CT3180-231WSA NEEDLE VALVE ASSEMBLY, OVERHEAD MOUNTED SINGLE

SUBMITTAL IDENTIFICATION SHEET

WEBSTER UNIVERSITY ISB	
PROJECT NAME	
8274 BIG BEND BLVD	
ADDRESS	
NUMBER	
WEBSTER UNIVERSITY	
OWNER	
CANNON DESIGN	
ARCHITECT / ENGINEER	
DEVIN D GATES	
SUBMITTED BY	
123553-001 REV 2	
CONTRACTOR / CM SUBMITTAL NO.	CANNON DESIGN SUBMITTAL NO.
	123553
DRAWING / DETAIL REFERENCE	SPECIFICATION SECTION / PARAGRAPH
MANUFACTURER / SUPPLIER	ITEM / PRODUCT ID
REQUIRED DATE	PRIORITY
	CRITICAL

DATE: 1/25/2017
JOB: 04437A, B, C, D
RE: Webster University
Webster Groves, MO

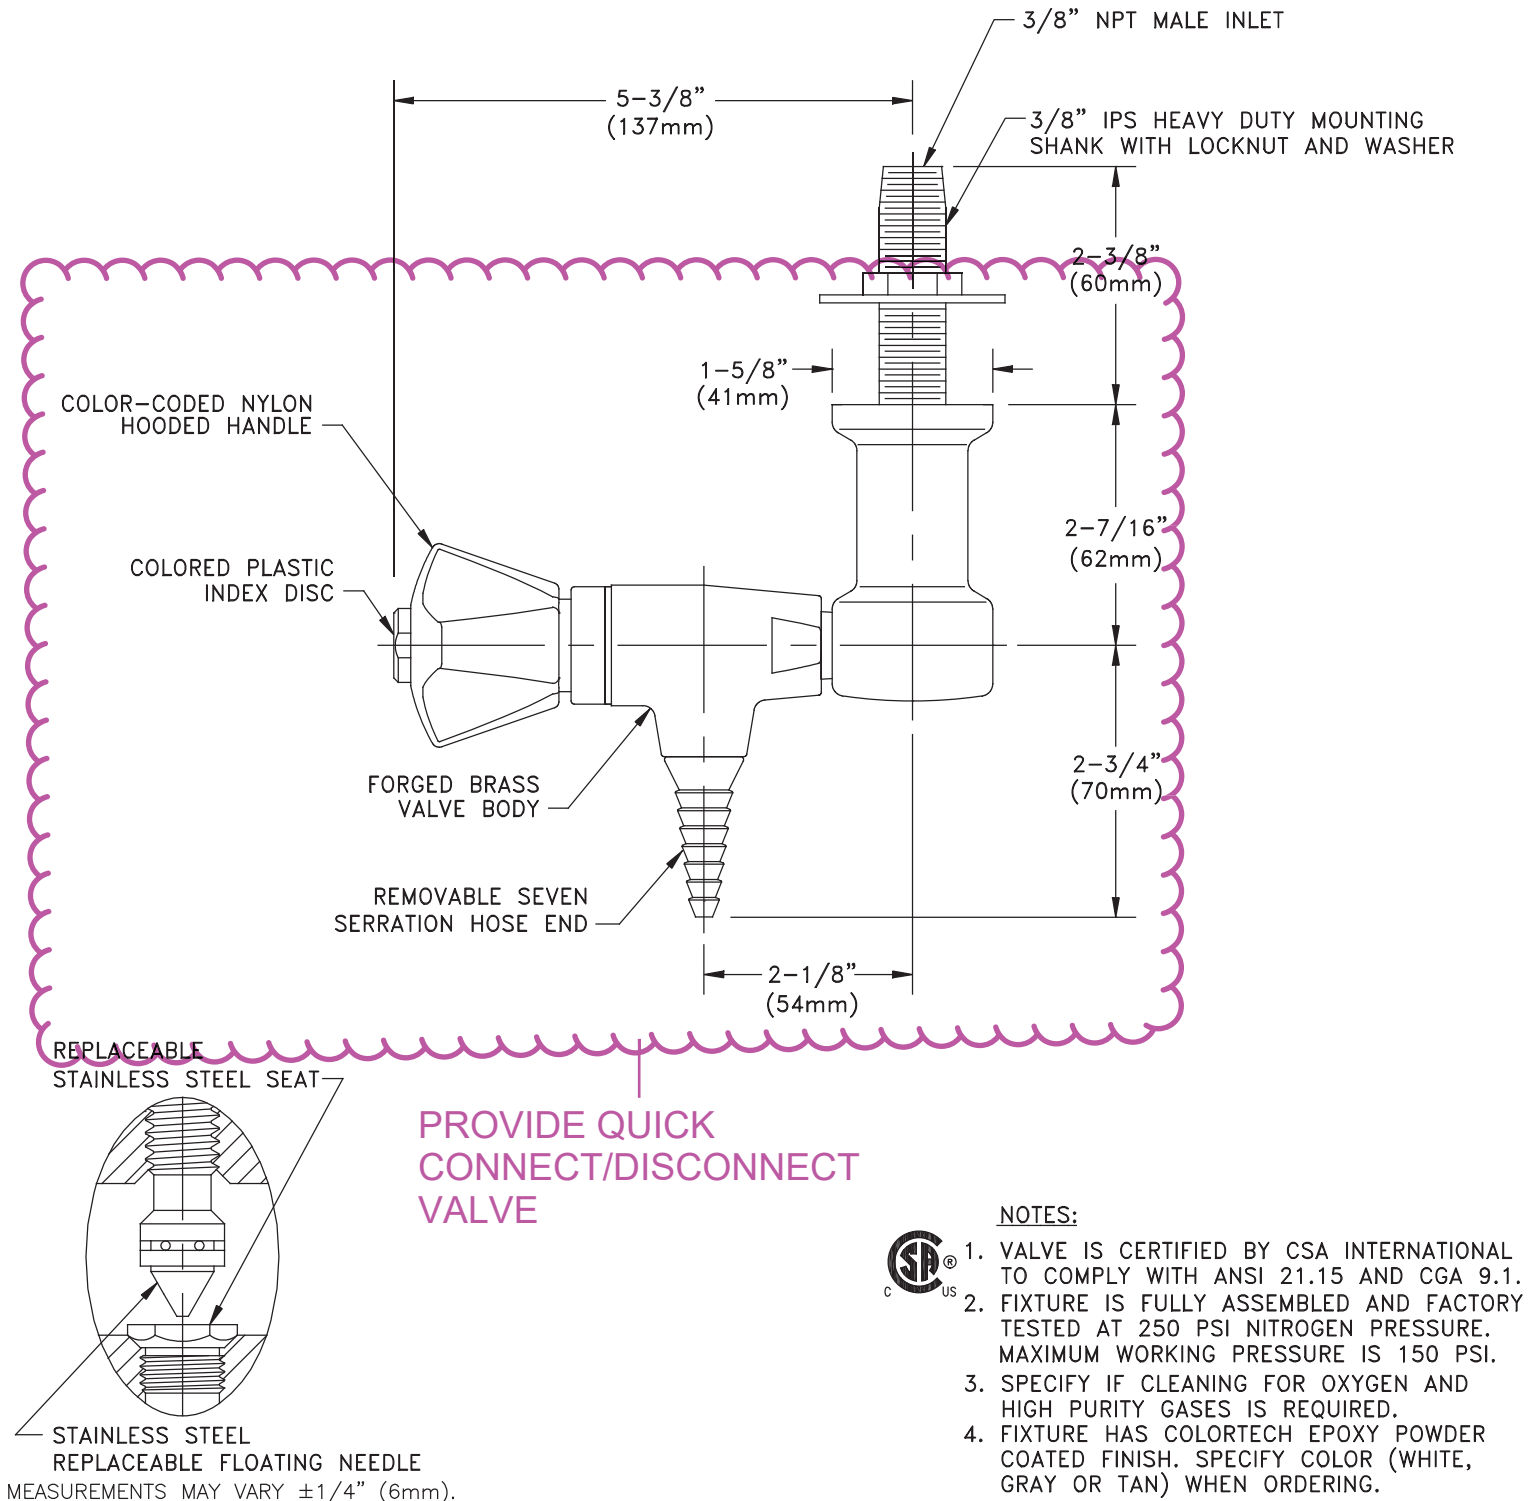
-PROVIDE PRODUCT DATA FOR V-5 AND A-5 (QUICK DISCONNECTS).
